<b>Case Number &amp; Name:</b>	PC 2019-12; Hubler Self Storage Facility, Site Development Plan			
<b>Petitioner's Name:</b>	Tony Nicholson, Site and Spaces			
<b>Owner's Name:</b>	Brad Hubler			
<b>Petitioner's Representative:</b>	Tony Nicholson/John Haines			
<b>Address of Property:</b>	1414 E State Road 44, Shelbyville, IN 46176			
<b>Subject Property Zoning Classification:</b>	IL, Light Industrial (With written commitments from the Common Council that require the property to be held to the BH – Business Highway development standards)			
<b>Comprehensive Future Land use:</b>	Gateway Mixed Use			
	<b>North</b>	<b>East</b>	<b>South</b>	<b>West</b>
<b>Surrounding Properties' Zoning Classifications:</b>	BH – Business Highway	BH – Business Highway	BH – Business Highway	BH – Business Highway
<b>Surrounding Properties' Comprehensive Future Land Use</b>	Gateway Mixed Use	Gateway Mixed Use	Gateway Mixed Use	Parks and Recreation

## Site Development Plan: PC 2019-12; Hubler Self Storage Facility, Site Development Plan

HUBLER STORAGE

DATE: JUNE 11, 2019	PROJECT NO.: 18074	SHEET NO.  C101	PROPOSED SITE/UTILITY PLAN	PROJECT NAME  HUBLER STORAGE 1414 E. S.R. 44 SHELBYVILLE, IN 46176	SEAL	CHECKED	SYMBOL	REVISION	DATE
						TN			
						CERT.			
						SCALE			
						1"=20'			
DRAWN	RC

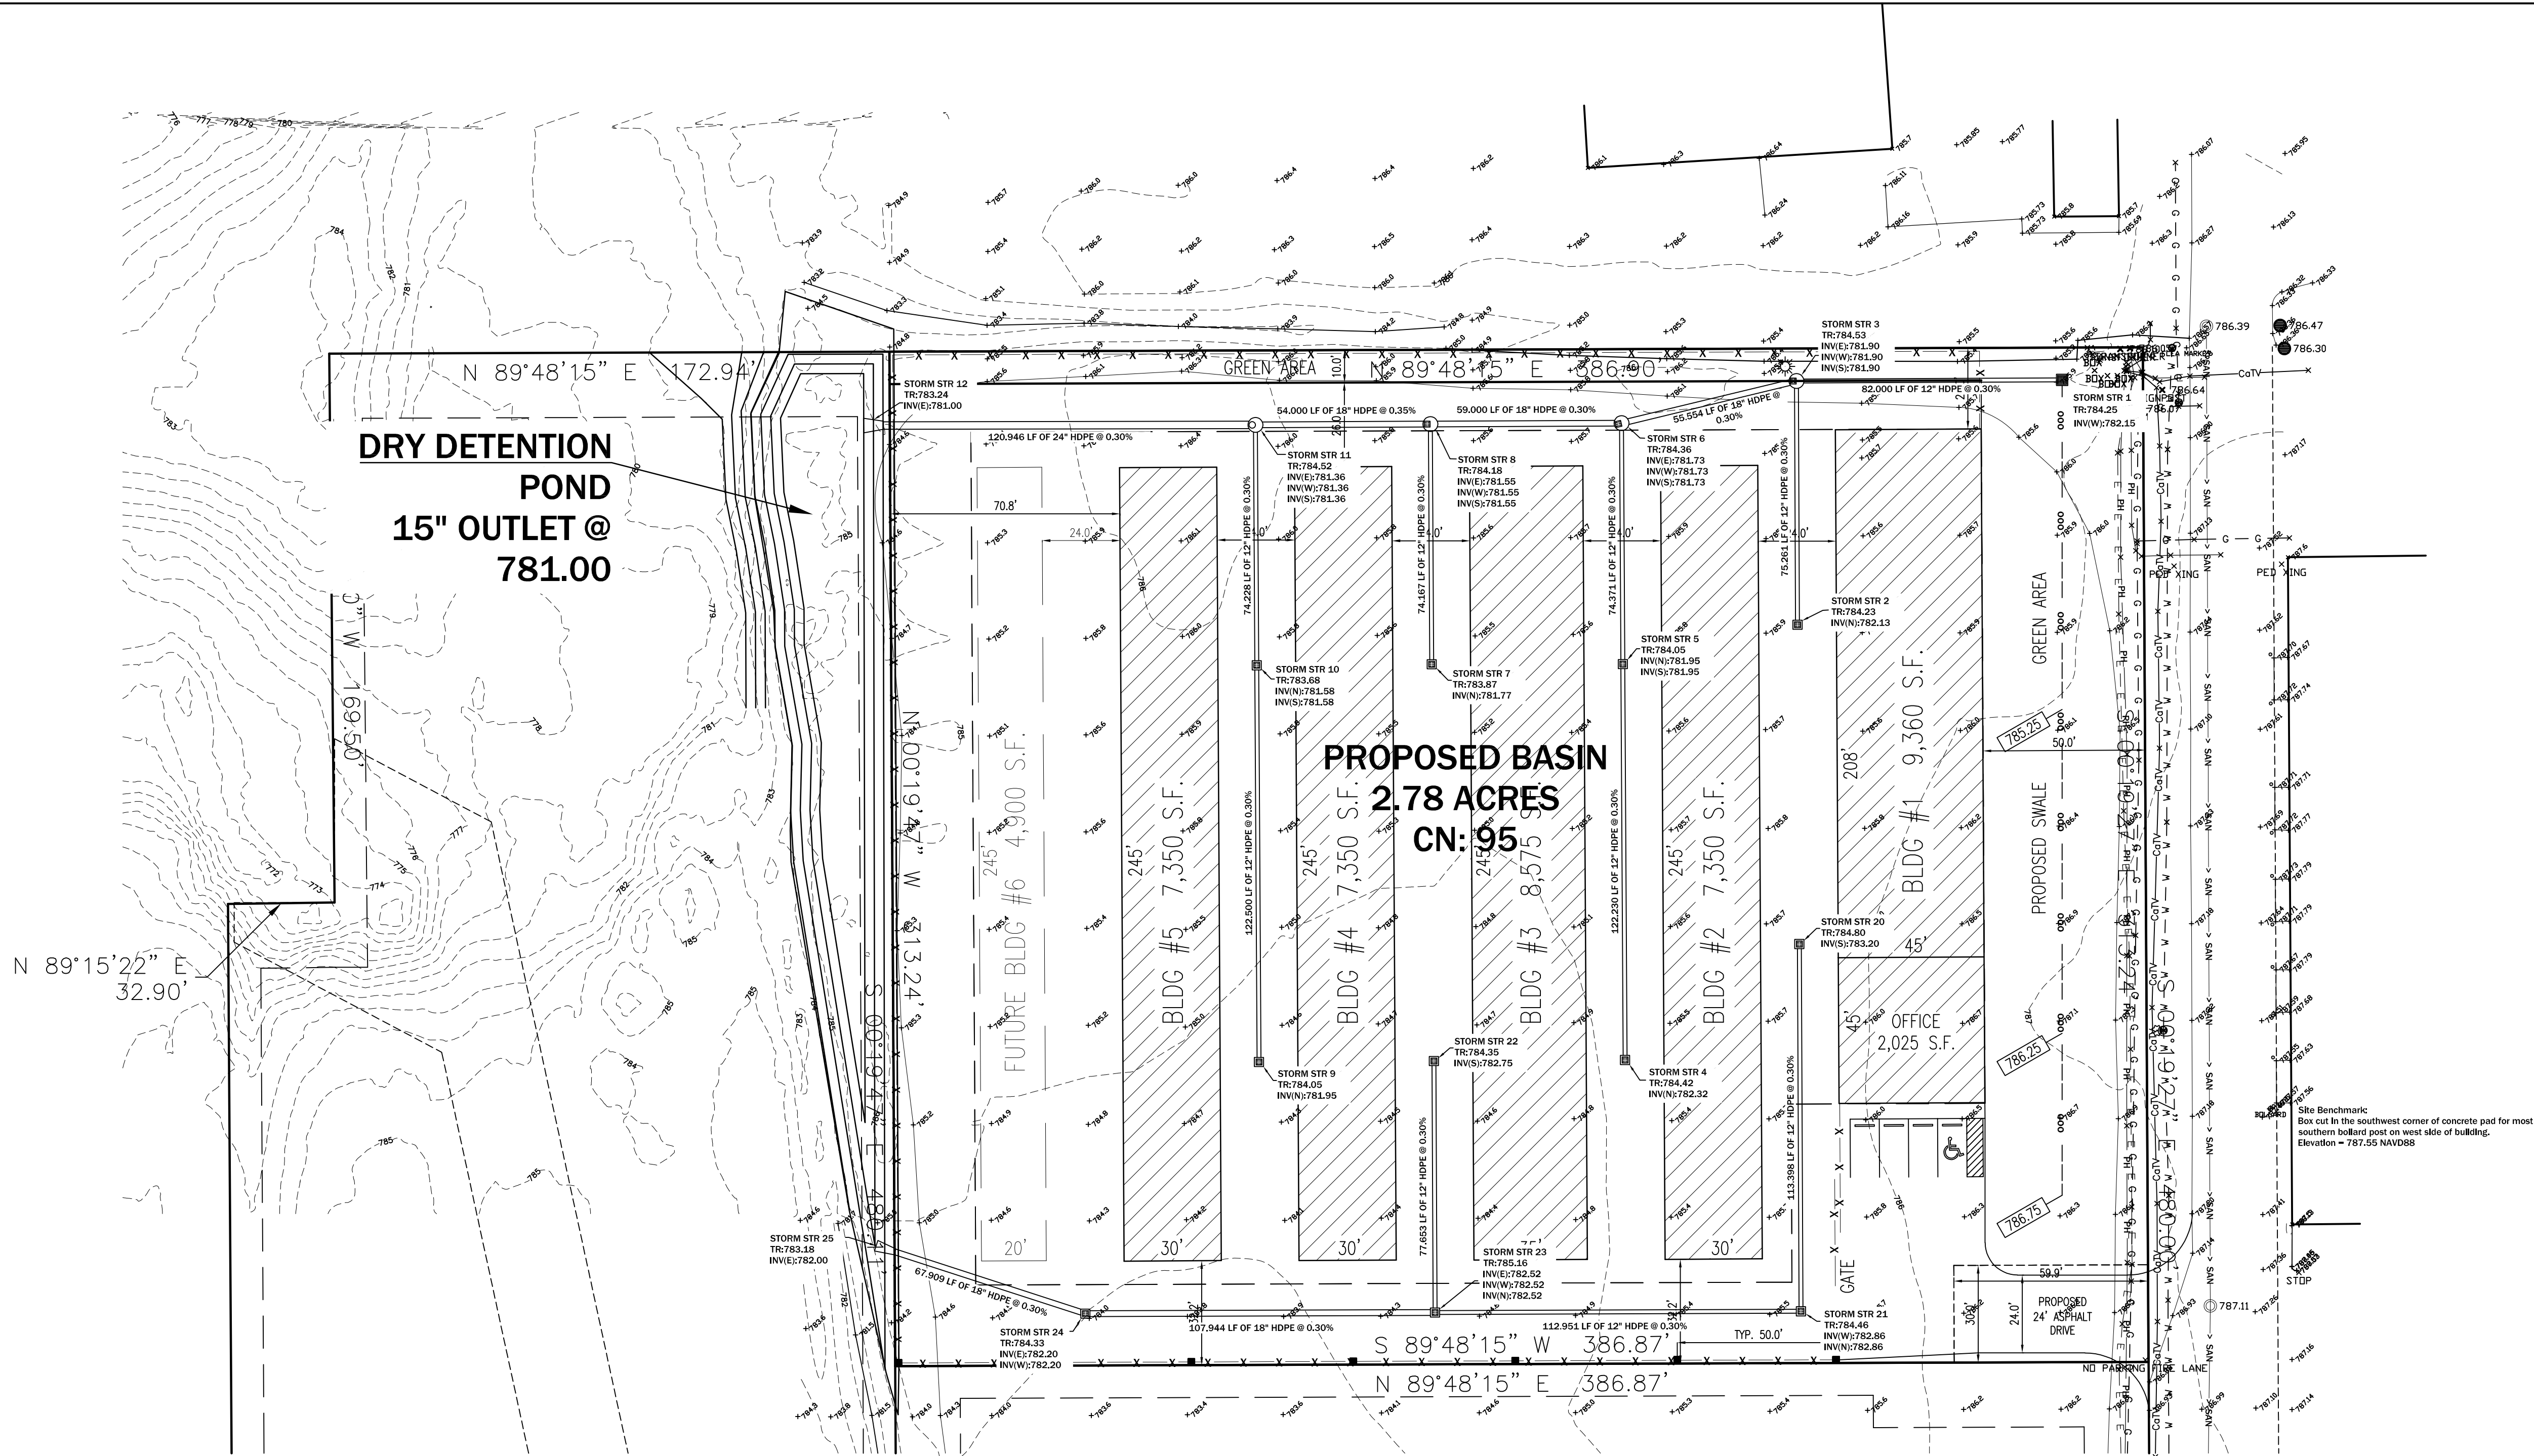
UDO 5.09 requires parking areas to provide safe, convenient, and efficient access. They should be distributed around large primary structures in order to shorten the distance to other buildings and public sidewalks and to reduce the overall scale of the paved surface. Additionally, a sidewalk is required to be installed when a new primary structure is constructed and sidewalks are also required to be installed in front of any lot created after the effective date of the Unified Development Ordinance. The subject property has provided access to the entrance of the facility from the parking lot, but is not providing a sidewalk for access from the public street or a sidewalk along the entire length of the eastern property boundary. Plans should be resubmitted showing the necessary sidewalks are being provided.

- 1. Resubmit plans showing the sidewalks that are required under the UDO 5.09 Commercial Standards**
- 2. Resubmit plans illustrating the height of the fence and a detail showing the design of the fence on the south side of the property as required by UDO 5.19 Fence, Hedge and Wall Standards.**
- 3. Submit a photometric plan showing compliance with the UDO 5.38 Lighting Standards.**

SHEET NAME  
PROPOSED SITE LIGHTING PLAN

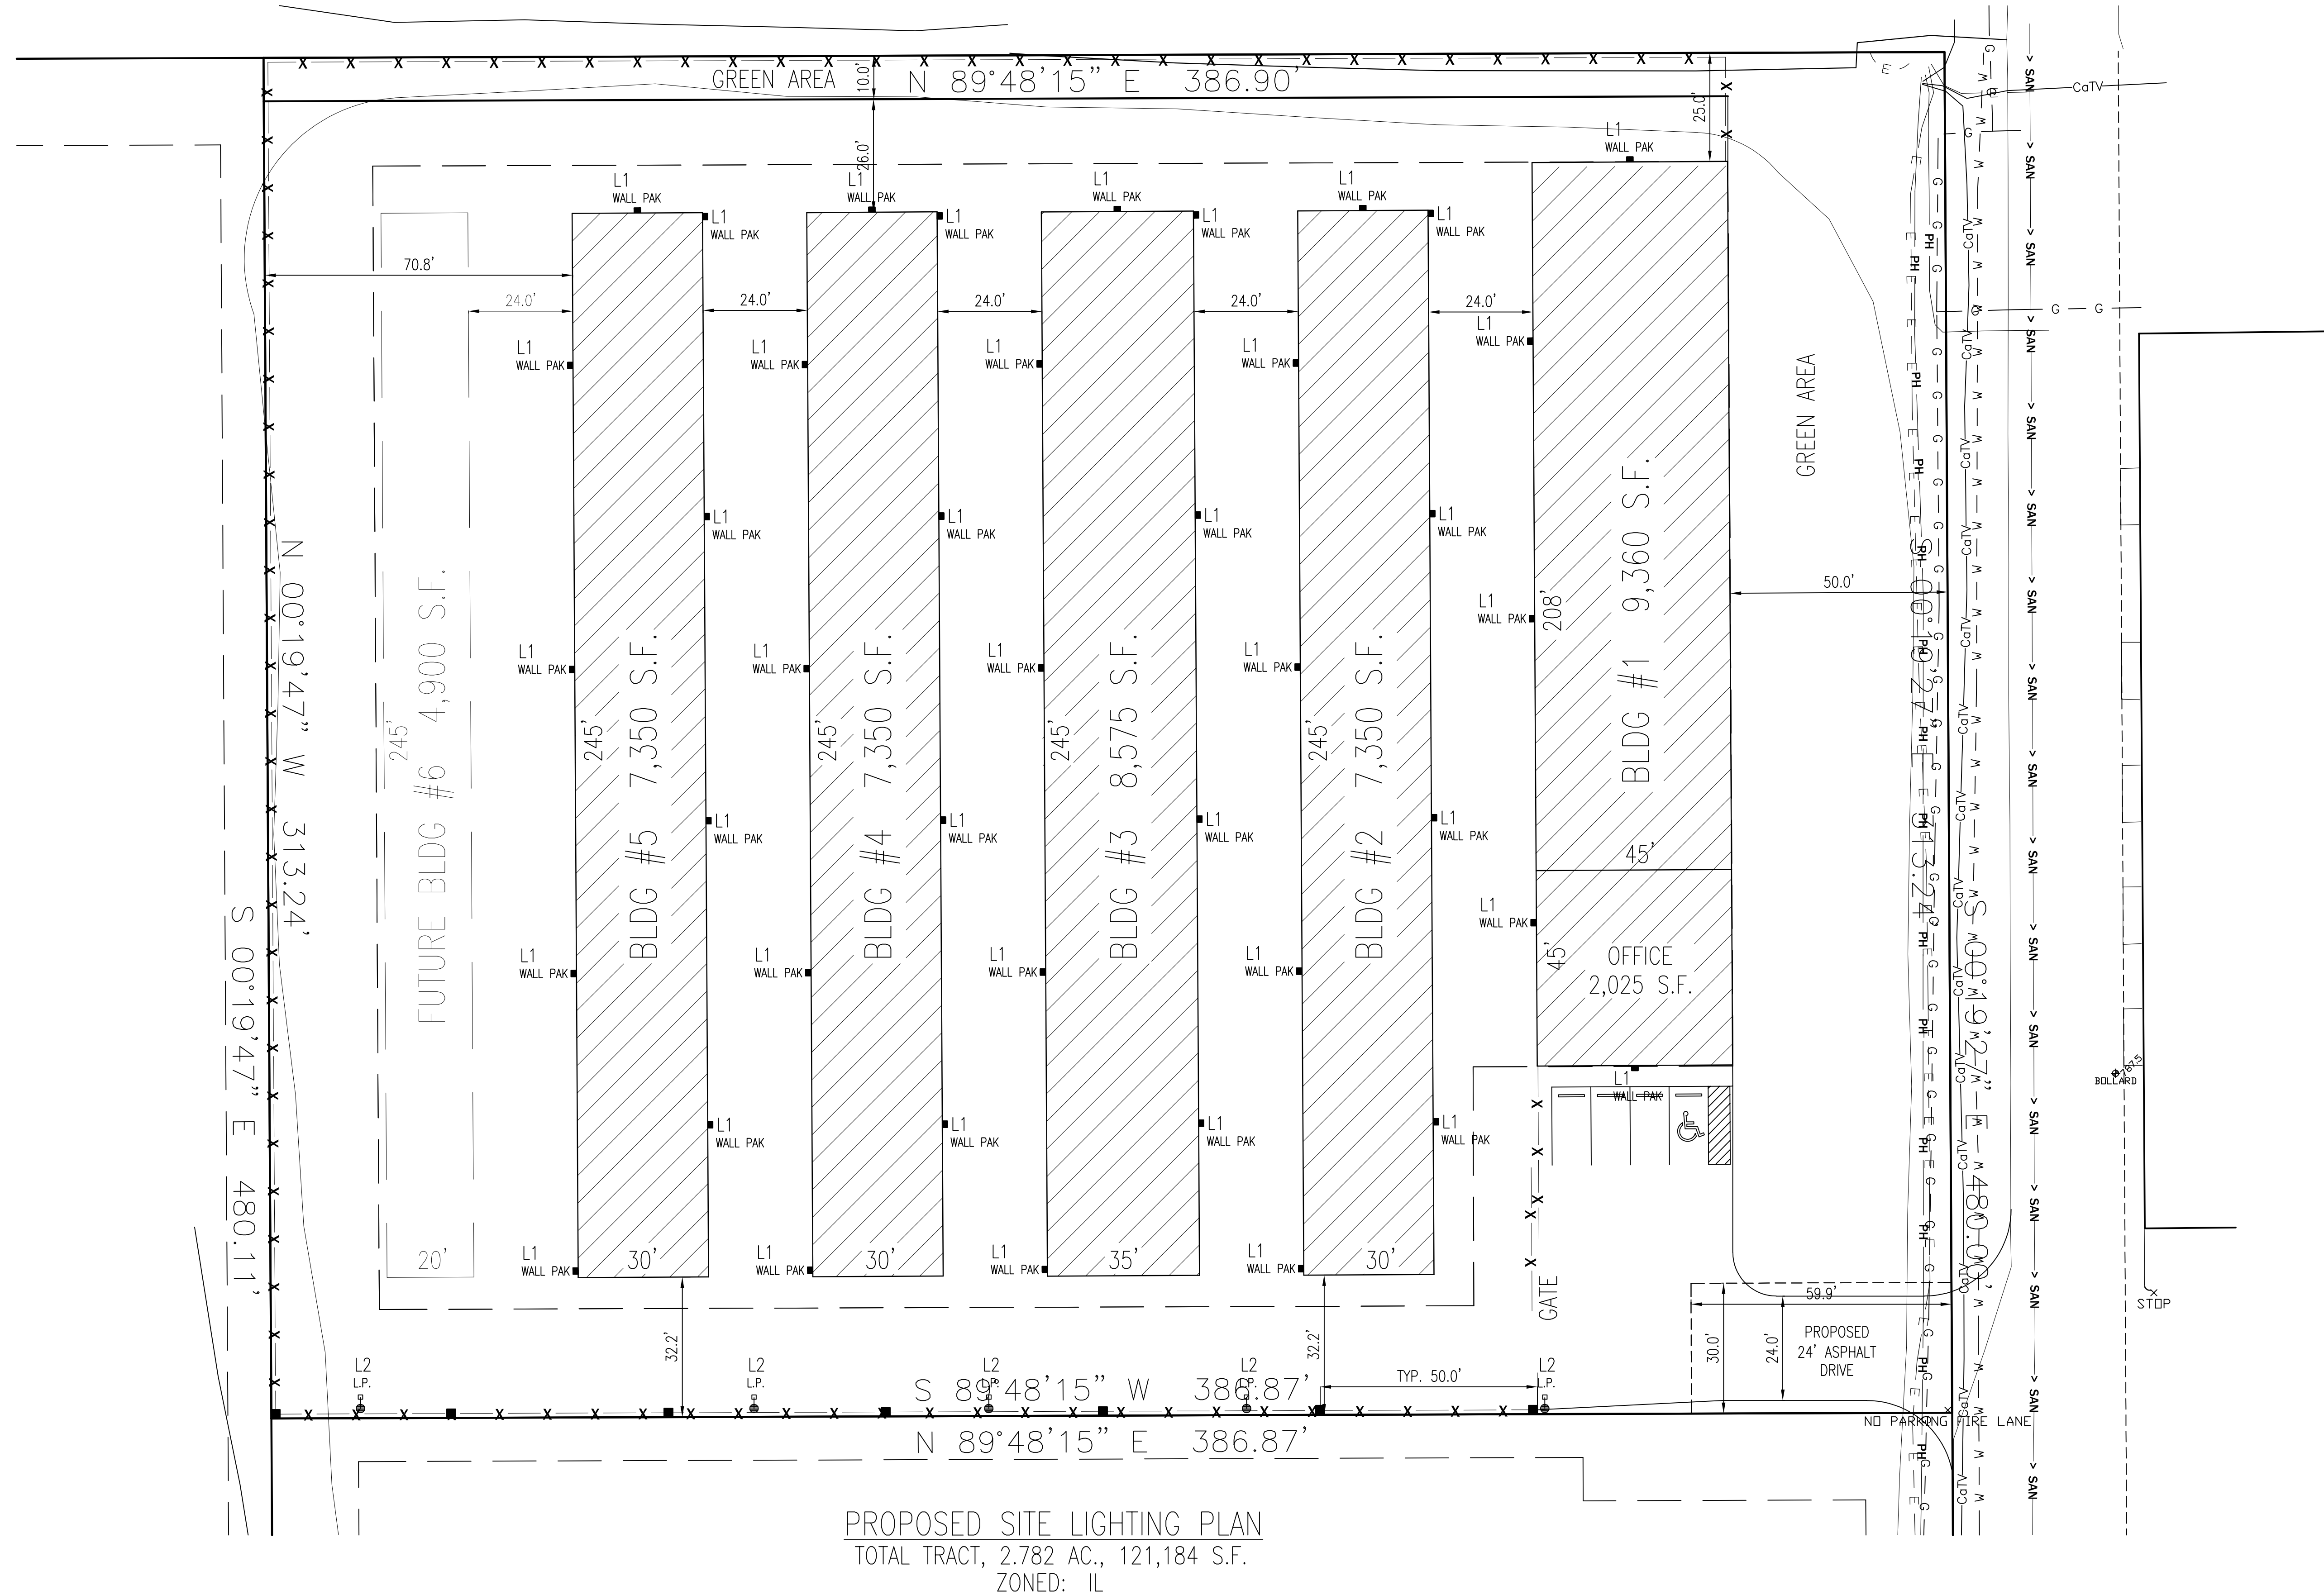
UDO 5.38 requires security lighting be at a ninety degree (90°) cut-off fixtures directed downward at the parking lot surface, loading docks, or doorways. All security lighting in non-residential areas shall be shielded and specifically aimed so that illumination is directed only to the intended area. The light source for any security lighting shall include shields that prevent their light source or lens from being visible from adjacent properties and/or streets. The use of general floodlighting fixtures shall be prohibited. Security lighting fixtures may be mounted on poles located no farther than ten (10) feet from the perimeter of the area intended to be illuminated. Any security lighting shall only illuminate vertical surfaces (walls, doors, etc.) up to a height of eight (8) feet from either grade level or the bottom of any illuminated door or entryway, whichever is greater. The maximum allowable light at a property line shall be five (5) lux, with the following exception: when the subject property is located adjacent to a commercial zoning district or an industrial zoning district, then the allowable light at the property line shall be twenty (20) lux, but only along the property lines that are adjacent to the specified zoning districts (i.e. BN, BC, BG, BH, IL, IG, and HI). The subject property is meeting these standards with all lighting attached to buildings with a ninety (90) degree cut-off and three (3) light poles on the southern side of the site. Plans should be resubmitted with a photometric plan ensuring light is not protruding onto adjacent sites.

SHEET NAME	PROJECT NAME	DATE: JUNE 11, 2019
PROPOSED LANDSCAPING PLAN	HUBBLER STORAGE 1414 E. S.R. 44 SHELBYVILLE, IN 46176	PROJECT NO.: 18074
		SHEET NO.
		C106

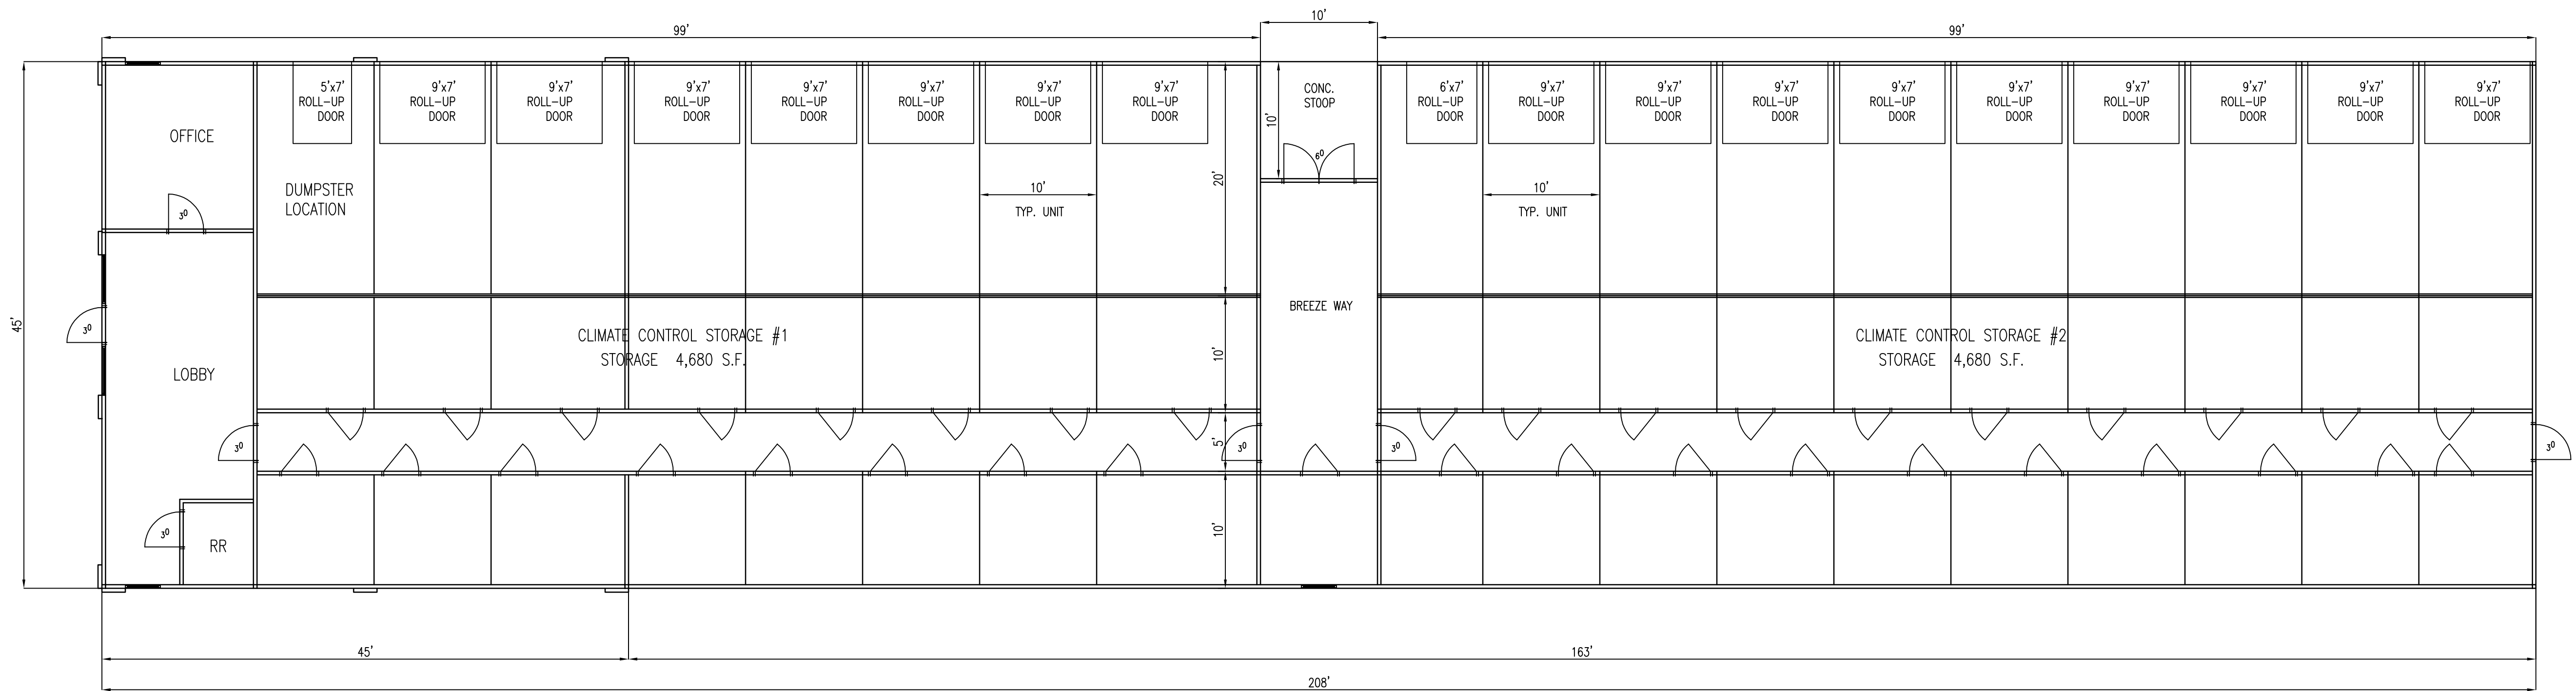
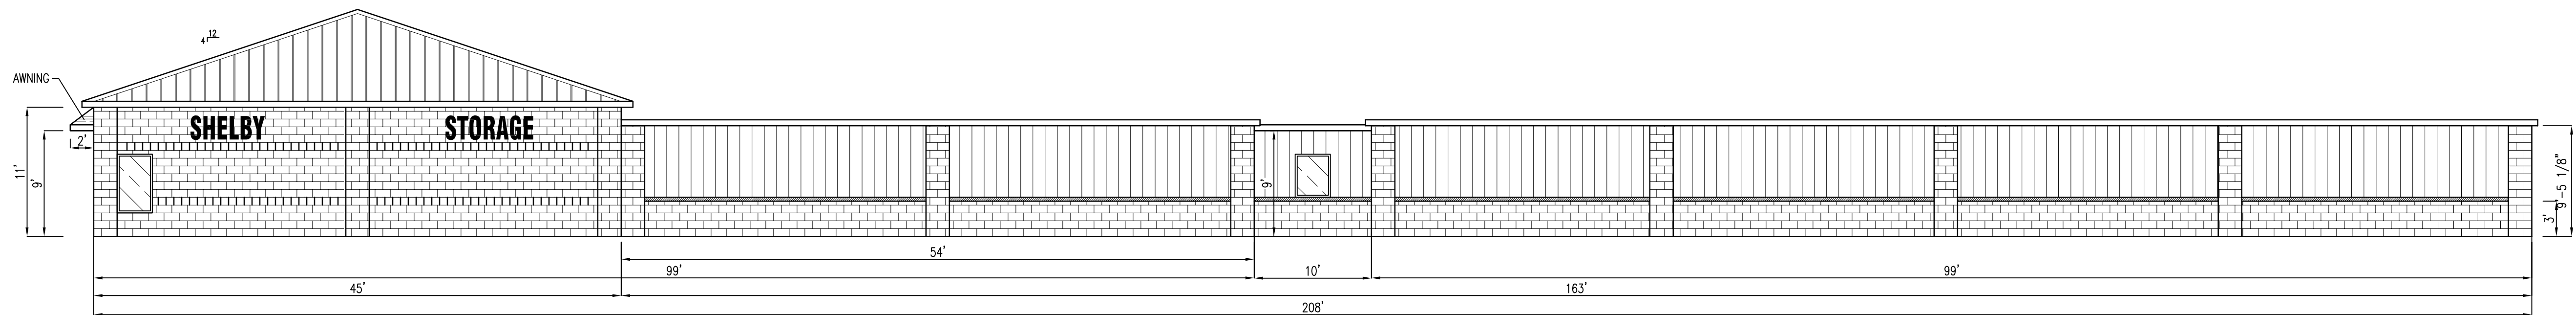
UDO 5.32 requires foundation and yard plantings. Facades of primary structure that face a street and are over eighty (80) lineal feet, shall plant one (1) shrub or ornamental tree for every twenty (20) lineal feet of facade frontage on a street. This provision applies to all facades that face a street. Additionally, one (1) shrub or ornamental tree per forty (40) feet shall be planted along side and rear facades. Additionally, lots over 20,000 square feet shall

plant two (2) canopy trees, plus one (1) canopy tree for every additional 25,000 square feet of lot size above 40,000 square feet. Under no circumstances shall more than ten (10) trees be required for this provision. Based on these standards the subject property is required to provide ten (15) shrubs and five (5) trees. The subject property is meeting these standards; they have provided six (7) trees and thirty-one (31) shrubs. Please ensure that planters do not block pedestrian access.
